**METROPOLITAN GOVERNMENT OF NASHVILLE AND DAVIDSON COUNTY**

**STAFF RECOMMENDATION**  
**2200 Grantland Avenue**  
**April 19, 2017**

**Application:** New construction- detached accessory dwelling unit (DADU); Setback determination

**Description of Project:** The applicant proposes new construction of a detached accessory dwelling unit at the rear of the lot. The applicant requests a setback determination from twenty feet (20') to ten feet (10') for the rear.

**SITE PLAN**

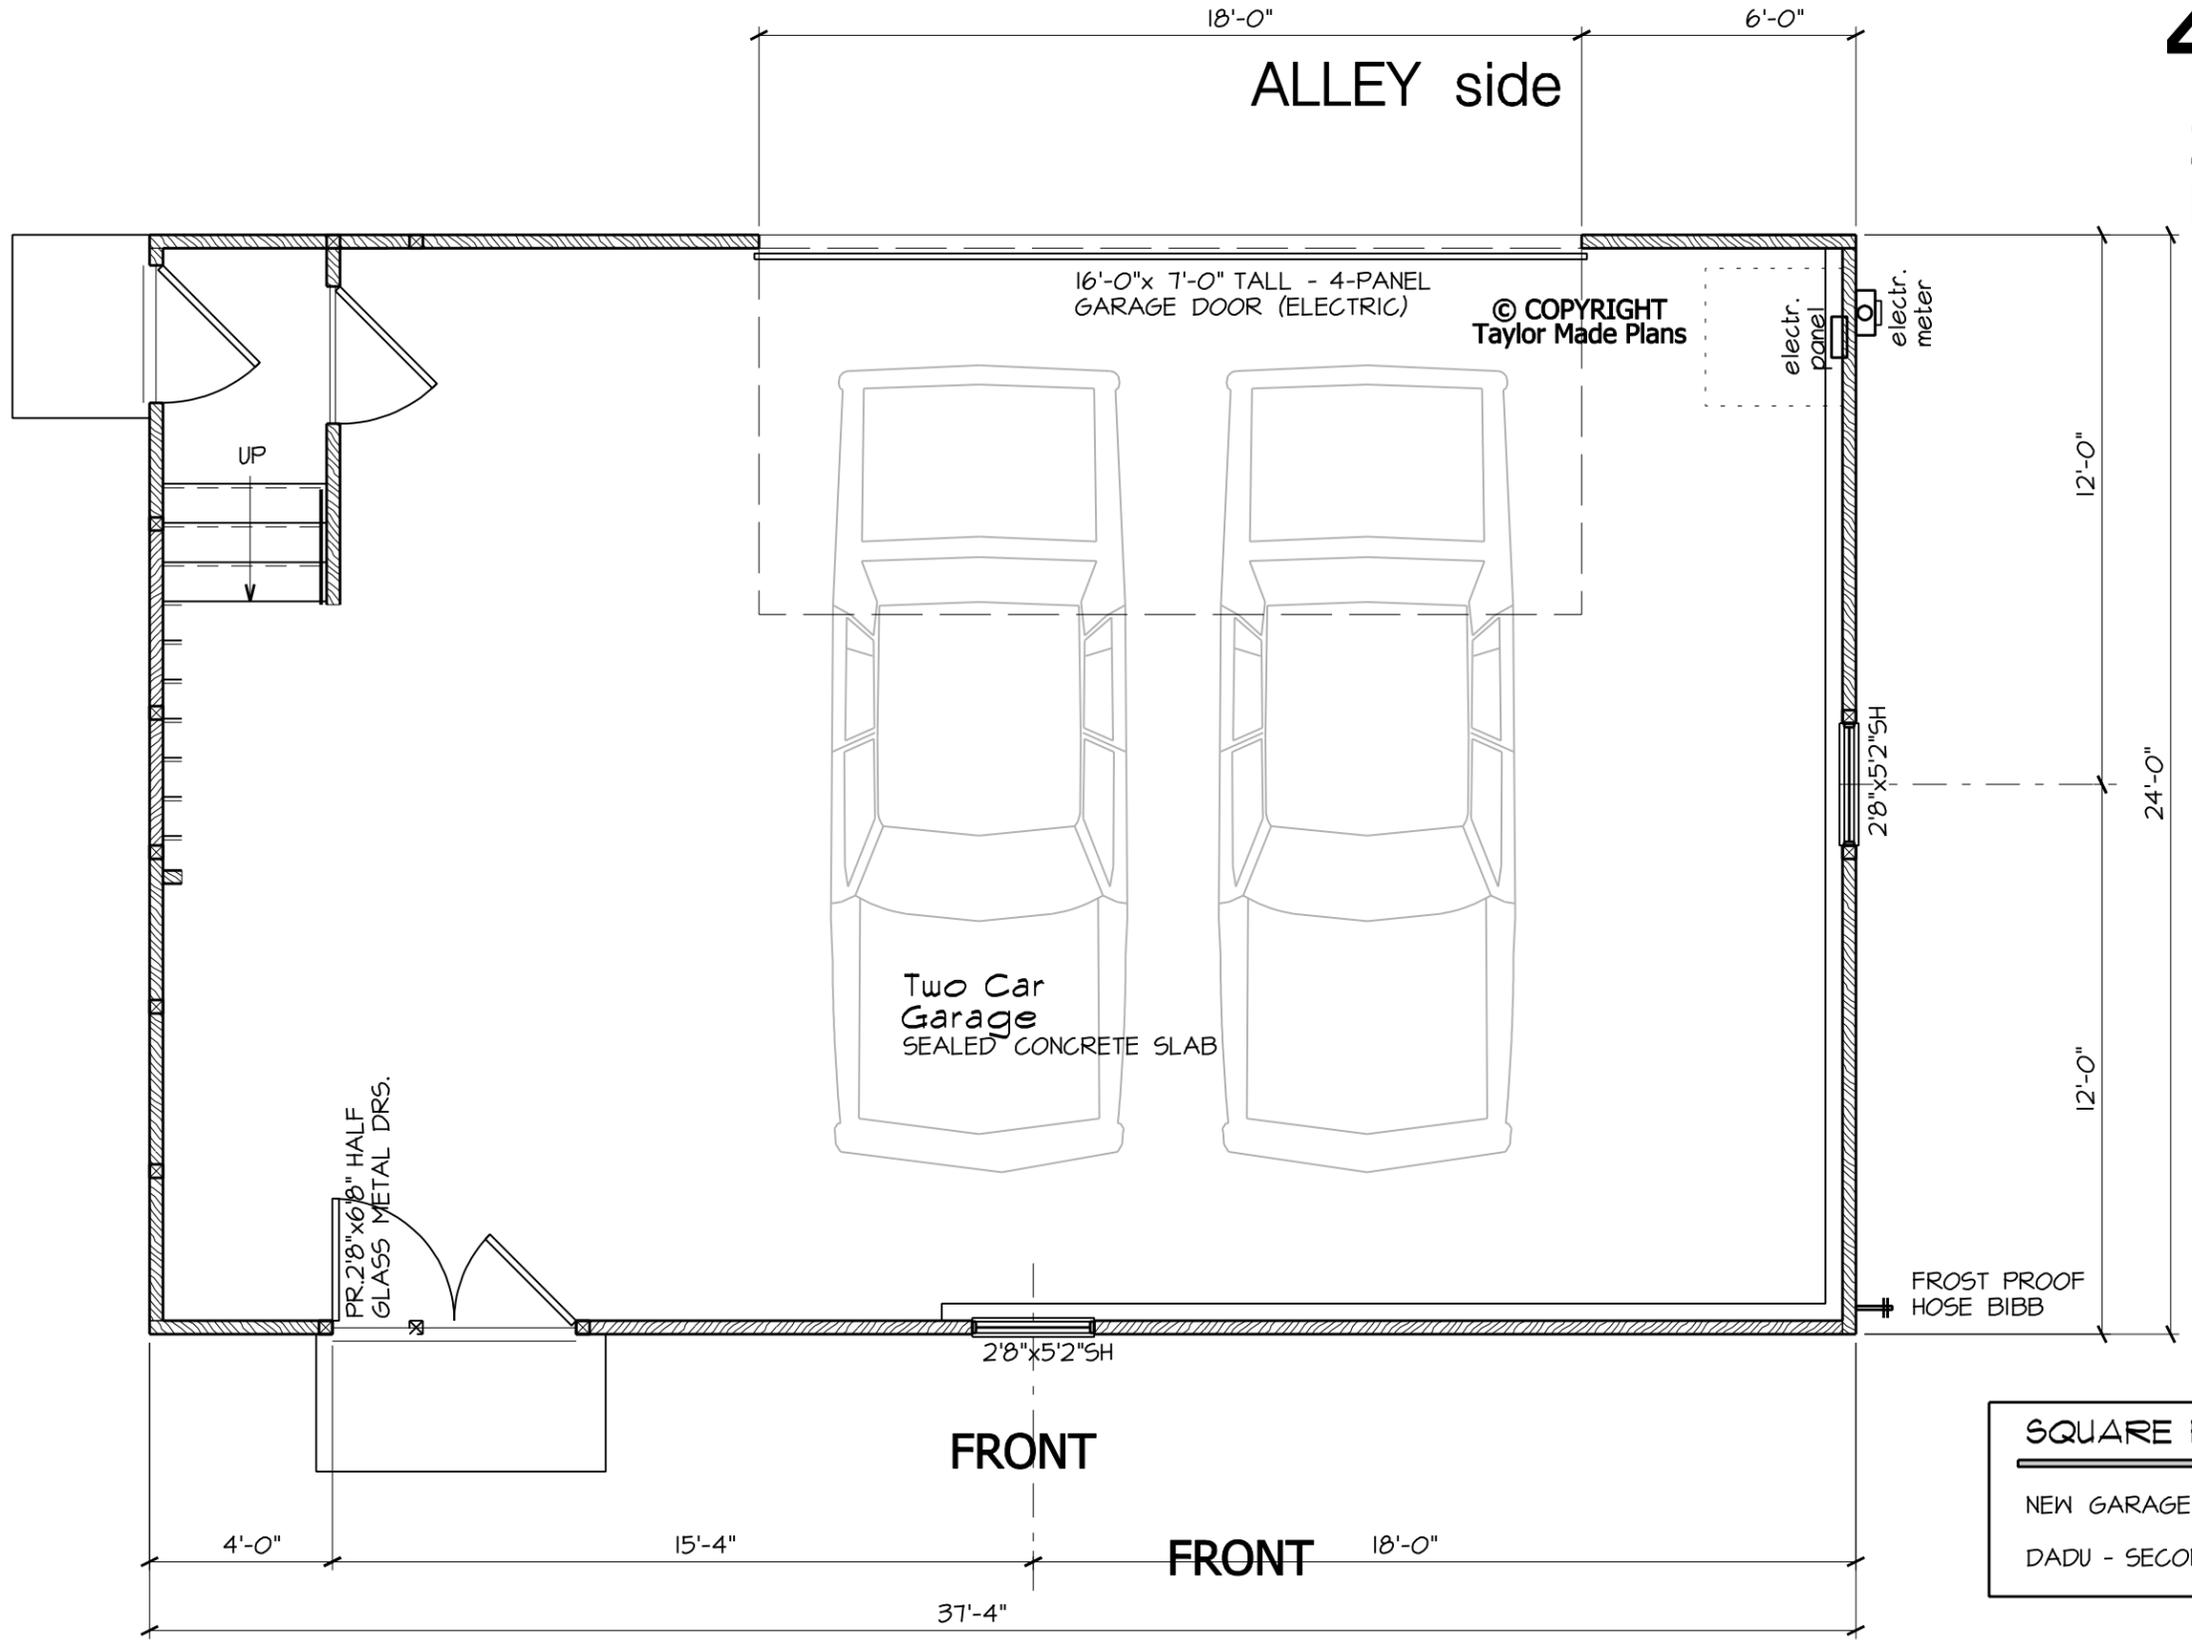
The applicant requests a setback determination for the new outbuilding from the rear property line. When an outbuilding has a footprint greater than seven hundred square feet (700 sq. ft.), base zoning requires that the structure be located twenty feet (20') from the rear property line and five feet (5') from the side property lines. It is proposed to be located five feet (5') from the right side property line and twenty-two feet, two inches (22' 2") from the left side property line, and ten feet (10') from the rear. Staff finds the proposed rear setback appropriate for several reasons. Recent outbuildings in the district have been approved with reduced setbacks. Historically, outbuildings were located at the rear of the property, close to the rear and side property lines. Also, the ten foot (10') rear setback will allow for more space between the historic house and the outbuilding. For these reasons, staff recommends approval of the setback determination.

**FRONT ELEVATION**

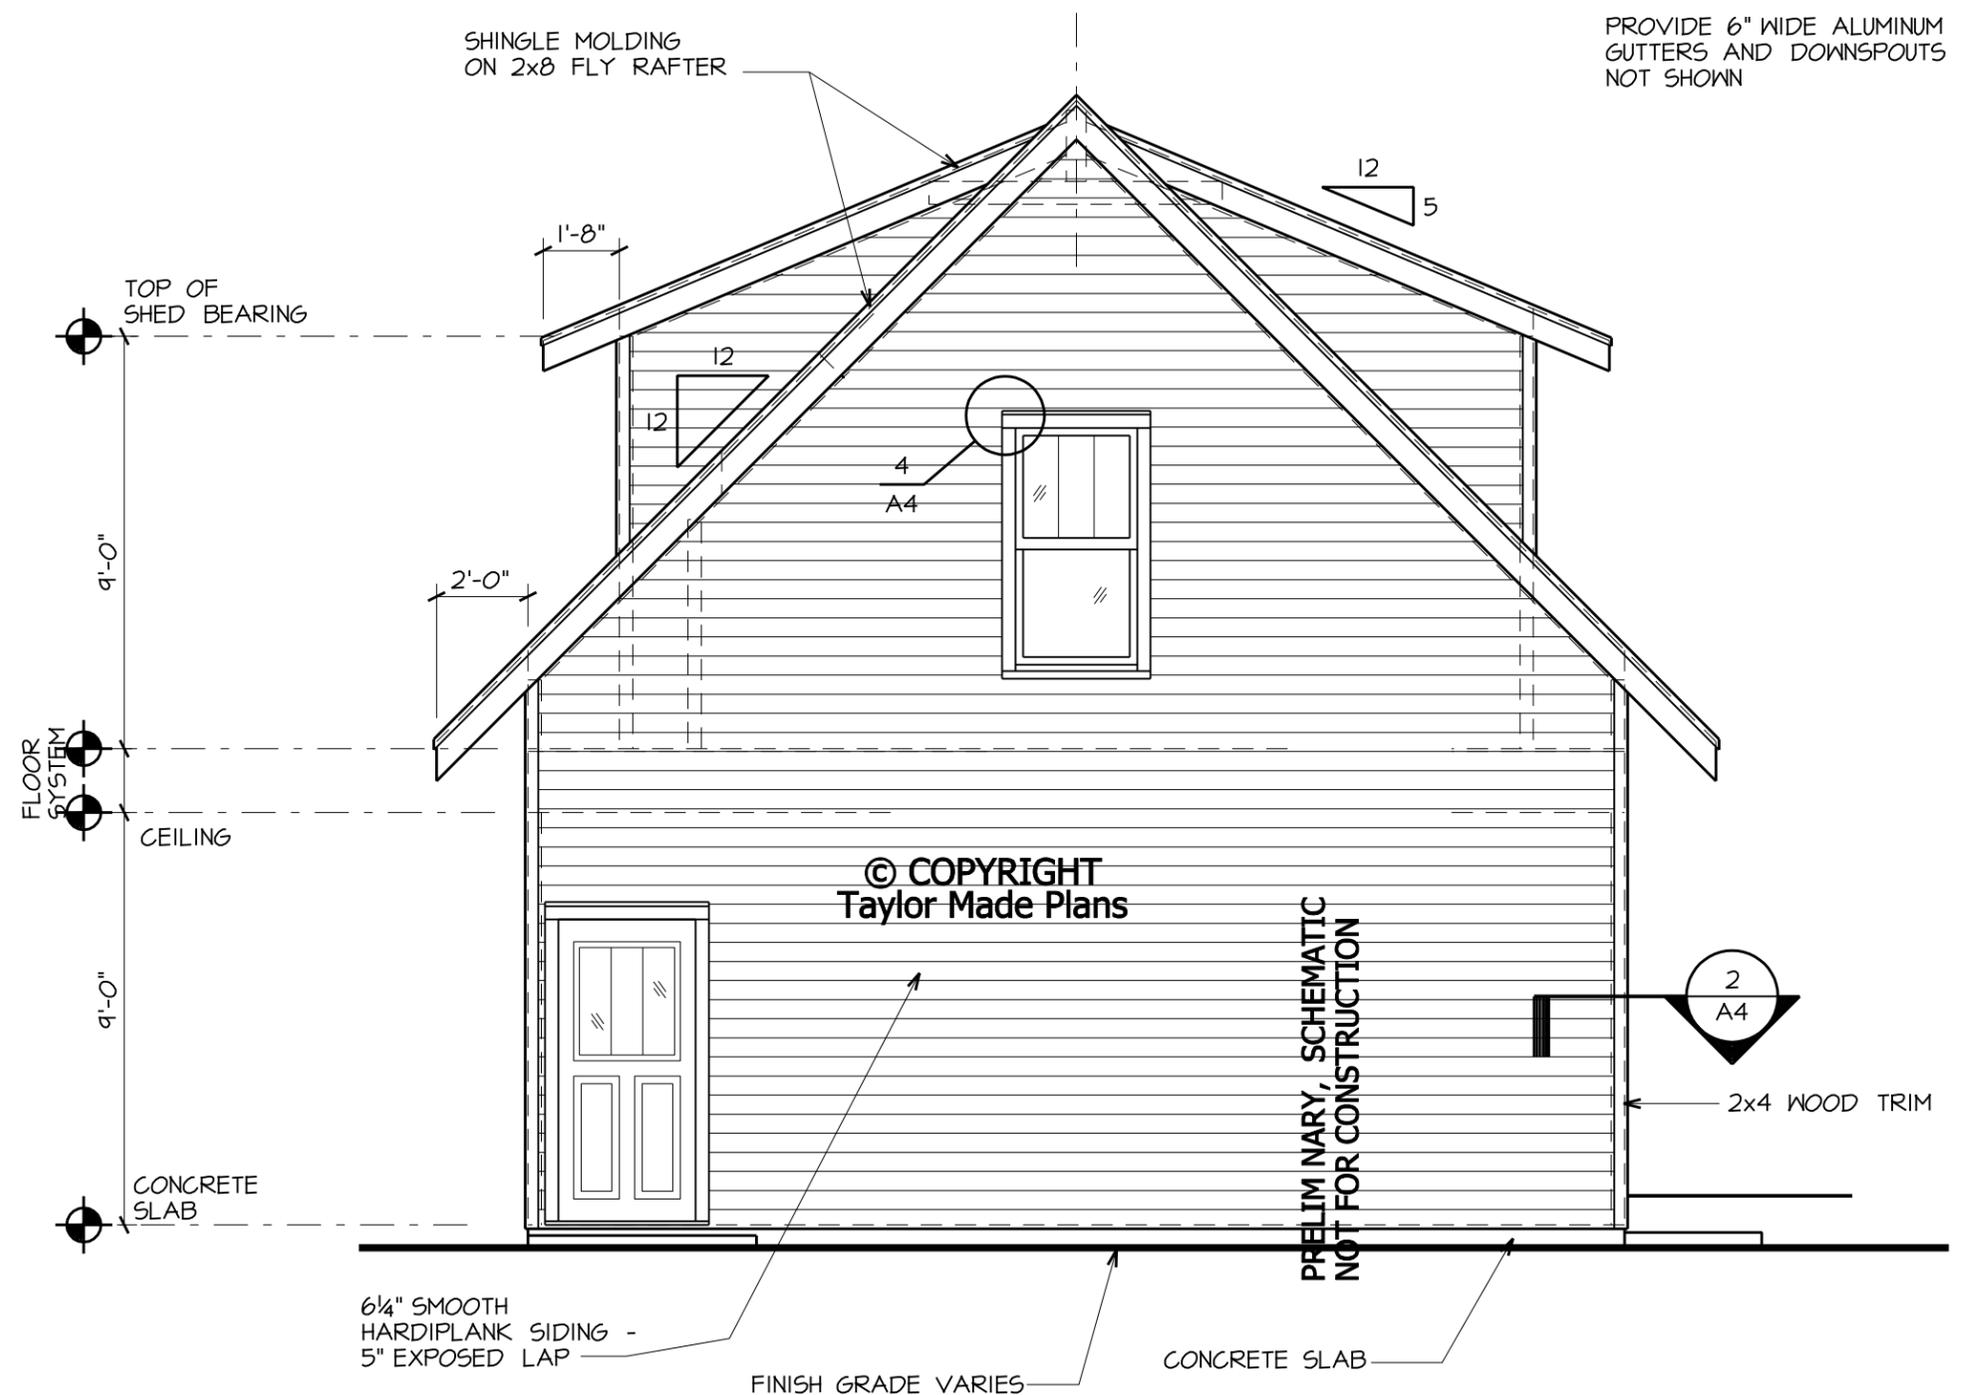
Materials: Details for the materials of the windows and doors were not indicated; staff recommends having final approval of the selections of windows and doors prior to purchase and installation.
